Technical Communication

TC No: **TC-100**
 Revision: **P01**
 Date: **28/05/2026**

Project Ref: **21052-LHO**
 Project Name: **Manchester Refurbishment, 90 Bridgewater St, M1 5JW**

SUBJECT: Non-validation – Louvre Details to Lee House

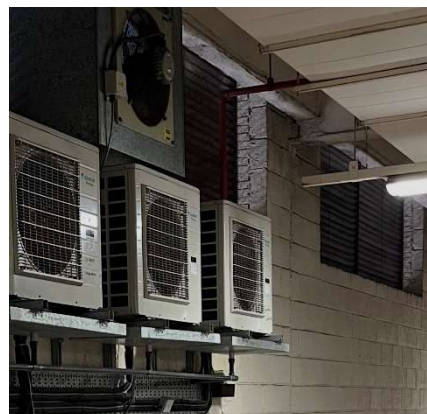
Confirmation has been requested on a louvre shown on drawing no.6486-KGA-00-00-DR-M-0400 Rev P03 within the basement of Lee House (extract below).

The project team has confirmed a new louvre will be provided but this will just butt up to the back of the existing louvres without the need to amend the existing louvre. There will be no additional penetrations to the elevation of Lee House and the new louvre will not be visible. An extract from Google Earth below shows the existing external louvres viewed from the Rochdale Canal Tow Path. A further photo has been provided showing the louvres from within the basement car park of Lee House.

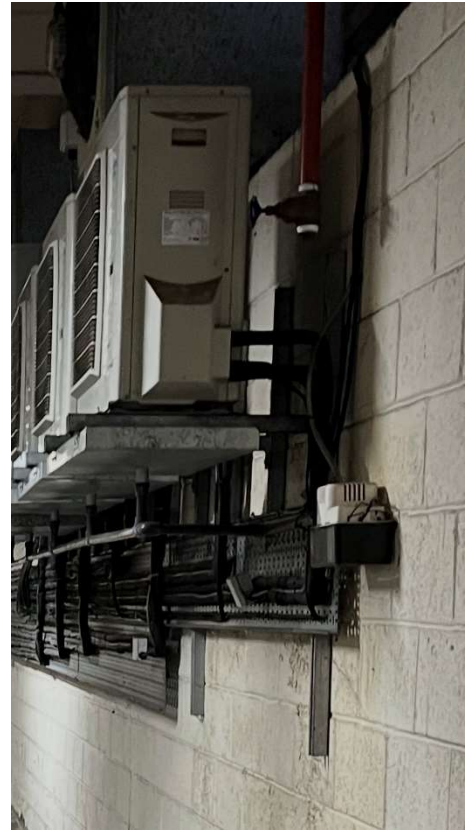
In addition to the above a further question was raised on the Listed Building Consent Application for Lee House (145664/LO/2026) regarding the air conditioning units. A section showing the arrangement and fixing details to the listed building were requested. The units will be arranged as per the existing and will be attached to the blockwork wall using uni-struts as per the existing units, as per the photo opposite.
